1 Products affected

2 Type of change

4754 Strip Block					0118.2241	
creation date	created by	release date	released by	notification no.	revision	page
2014-09-15	hotzar	2015-02-17	hotzar	27061		1 of 2

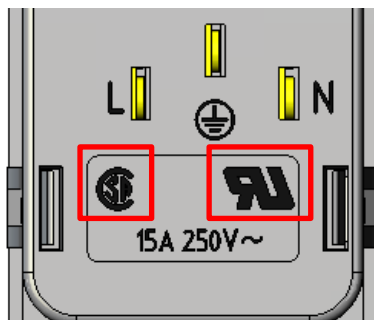
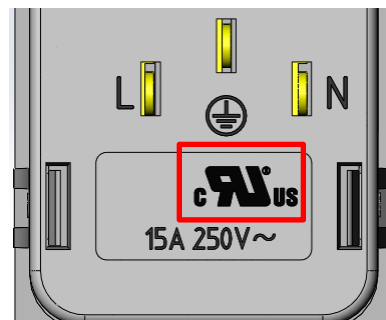
Modification of approval marks.
Slight modification on the lateral indentation.

New combined cURus approval mark instead of separates UR and CSA marks.
Slight modification on the lateral indentation.

Form:	Yes	Slight modification on the lateral indentation.
Fit:	No	There are no dimensional changes.
Function:	No	No change on the specification.
Production Site:	No	There is no change of the production site.
Product Label:	Yes	CSA and UR marks replaced by cURus mark.

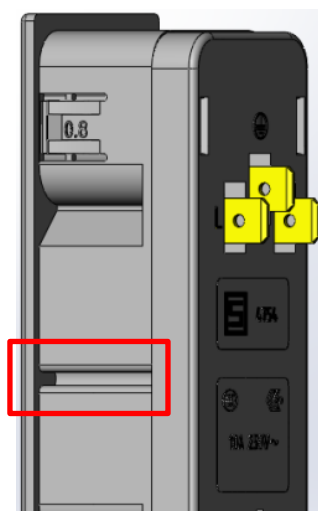
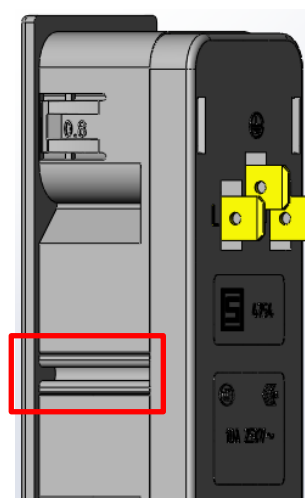
Consolidation of North American approval marks with the combined cURus mark.
Slight modification on the lateral indentation because of optimization of the injection process.
